ICOMOS ADVISORY MISSION

DEFENCE LINE OF AMSTERDAM
KINGDOM OF THE NETHERLANDS

REPORT
Proposed Highway Link A8/A9

Dates of mission: 5th-7th October 2017

Image 5: Zero-plus alternative, with possible cross sections.

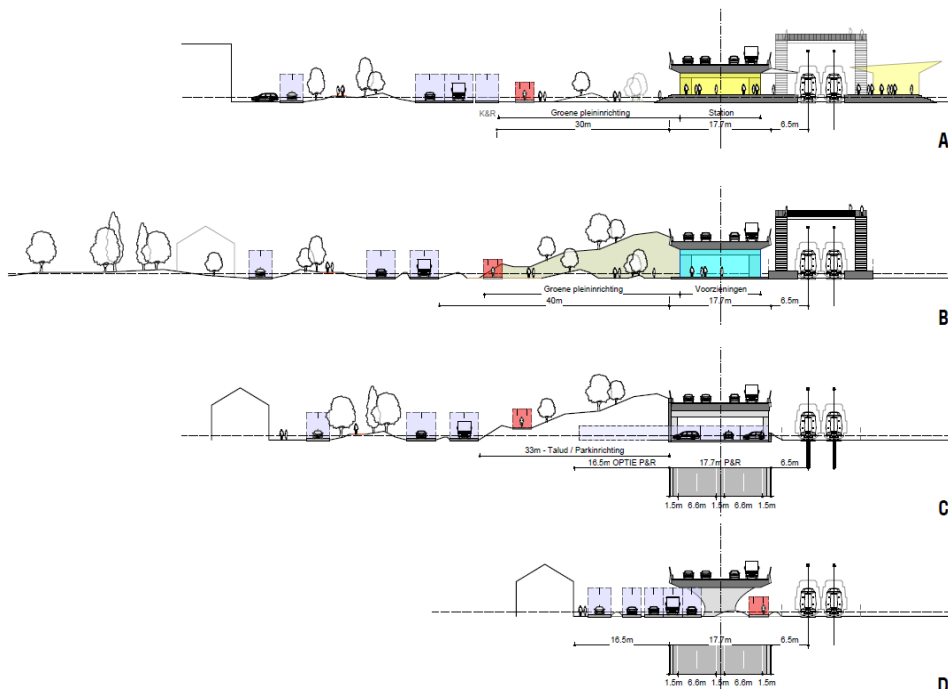
As regards the Zero-plus alternative, cross sections included in the design booklets show the difficulty of managing traffic in a densely-populated area. Motorway traffic will be diverted here, and there will be increased railway traffic as the new train depot is going to be built close to the N203 /A9 junction, implying trains every 6 minutes. In addition to this, there is a canal used for shipping merchandise, plus the crossing traffic between Krommenie and Assendelft, both transport and by foot, as many of the town’s facilities (around 35.000 people and 8 schools are situated less than 200 metres from this road) lie at one side or the other of the new proposed link.

With reference to transport solving, this alternative has an important default in that it implies a derivation of the A8 traffic on a short segment of classical road (N 203) before joining the A9, which could be not entirely satisfactory in the future due to traffic jam problems.

Image 8: Golf Course alternative, showing the planned layout, with the three nodes, as well as mitigation

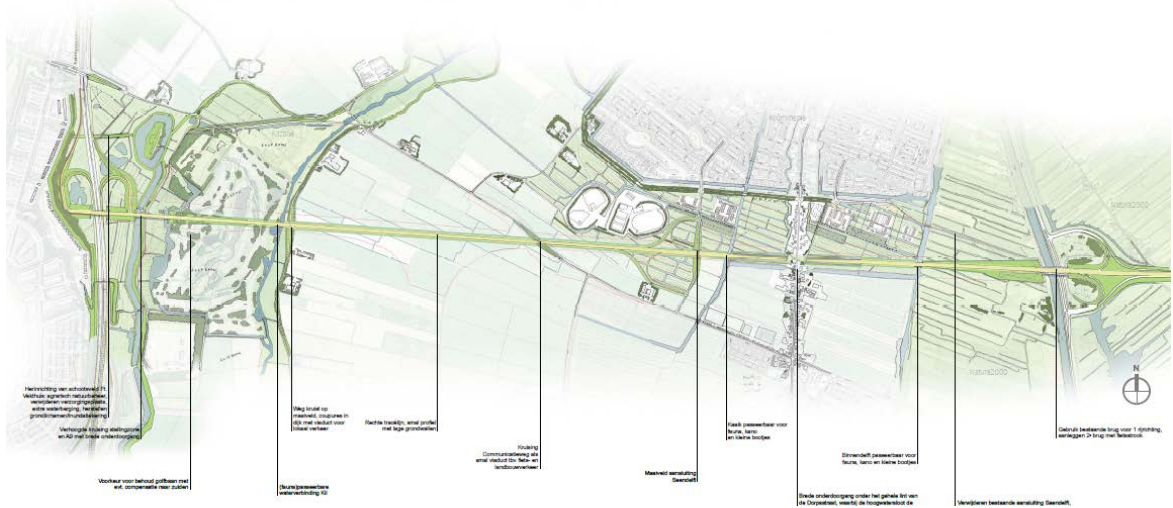
As regards transport solutions, taking into account ICOMOS's review by transport specialists, traffic levels in Assendelft and Krommenie may be lowered, reducing air and noise pollution. This option requires a new junction on the A9, not far from the A9/A22 junction, where, presumably, both roads have high traffic flows and vehicle speeds. Locating the new junction in very close proximity to the existing A9/A22 junction may result in vehicles blocking back and heavy queuing due to the short

merging and diverging sections. For the motorist arriving or heading on the A9 North, the existing N8 road route may still offer similar travel time and, therefore, it is possible that the new link road will be underutilised.

Image 9: Golf course alternative, with the ramp of the viaduct crossing across the property's area.

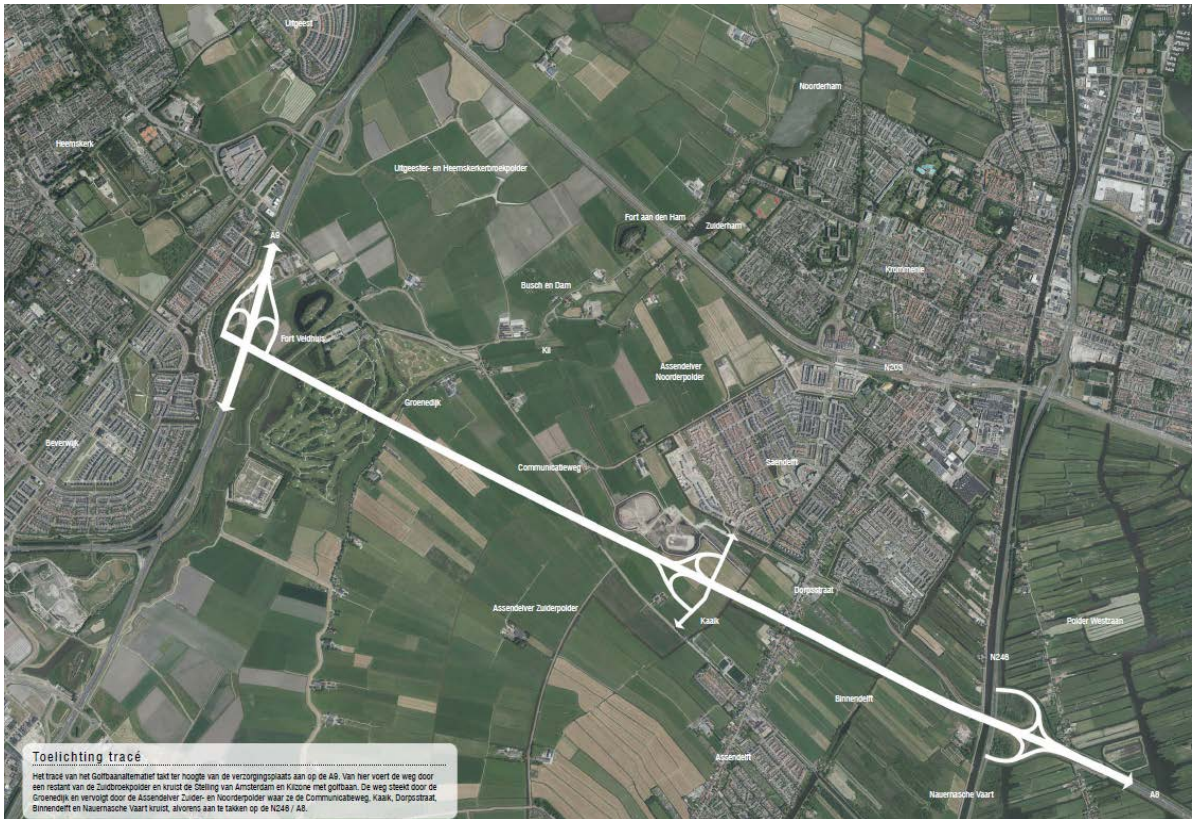
Alternative 3 would lead to a change in some important historic landscape structures of the World Heritage Site. The road would pass the main defence line in two places: as a fly-over over the main defence line (St. Aagtendijk) and in a cutting through the second line rampart (Groenedijk). This double rampart located here is unique anywhere in the DLA. Constructing a fly-over would allow the St. Aagtendijk to remain intact as an element. However, the cutting through the second line rampart (Groenedijk) would mean that part of this dike would no longer be intact. There would therefore be a moderate adverse effect (2).

Construction of the road would lead to a minor change. Openness and lines of sight were important aspects in the design of the military system and the function of the forts: defence required a free field of fire. Construction of the Link Road and the fly-over would lead to the openness and visibility (open field of fire) being lost. However, the sense of place and understanding of the relationship between the St. Aagtendijk, Fort Veldhuis, the associated secondary battery, and the free field of fire would also be affected.
